SPECIFIC DEFECTS REPORT

**Independent Survey
for roofing work
new build
at
XXXX
Wyboston
Nr Bedford
Bedfordshire
MK44 X**

**Roof problems
new build**

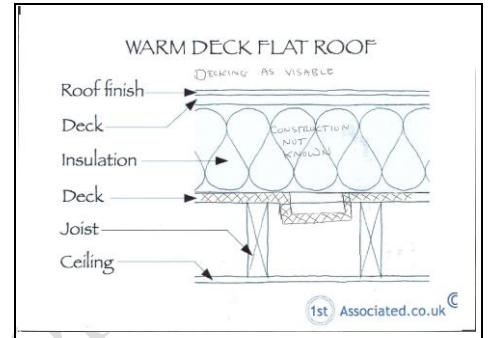
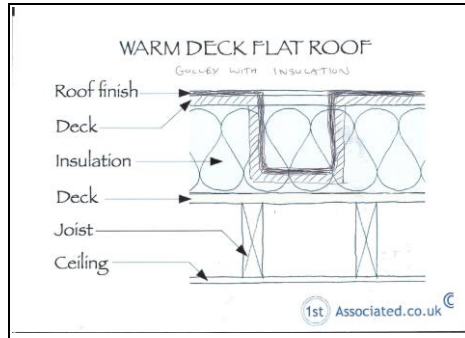
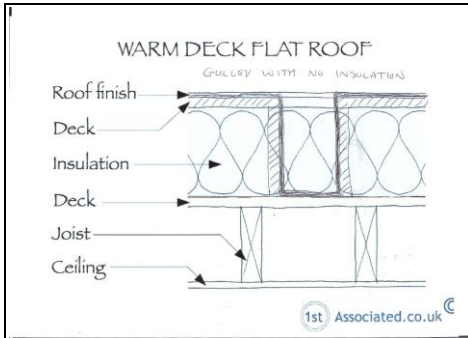
Without opening up the structure it is not possible to understand exactly how the gulley runs have been constructed. It may be that the existing gulley may cause cold bridging (as we believe the cast iron to the outlet is doing) as you can see from our sketches.

1. Gully with no insulation and possibility of cold bridging

2. Gully with a small amount of insulation possible cold bridging

3. Gully as visible

As you can see from our basic sketch details dependent upon the amount of insulation cold bridging may occur and condensation.

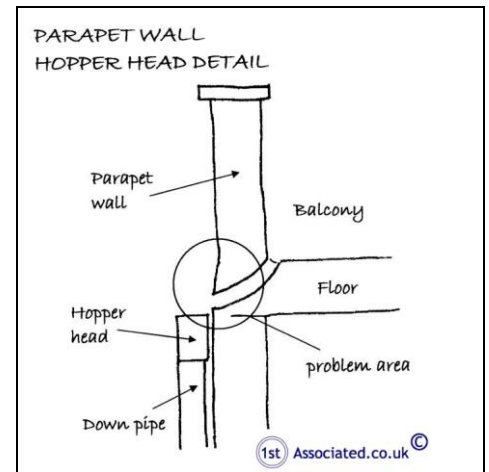
Damp meter readings underside of the gully

Dampness readings taken to the timber decking internally indicated that dampness is still coming through particularly around the outlet and box gutter detail although the readings obtained from the box gutter detail may be being transferred from the outlet or indeed other areas in the roof.

11.1) To continue with the internal downpipes which will mean making a waterproof seal between the new waterproof surface and the drainage outlets. We would, of course, recommend you ask XXXX to specify exactly the right kind of drainage outlet.

11.2) To provide an external downpipe in the form of a hopperhead.

Close up of area of surface coming away

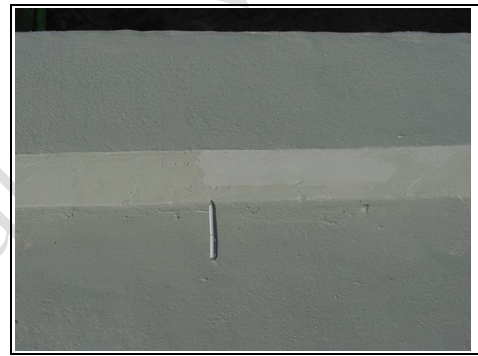
To the front left side there is surface deterioration with the surface coming away.
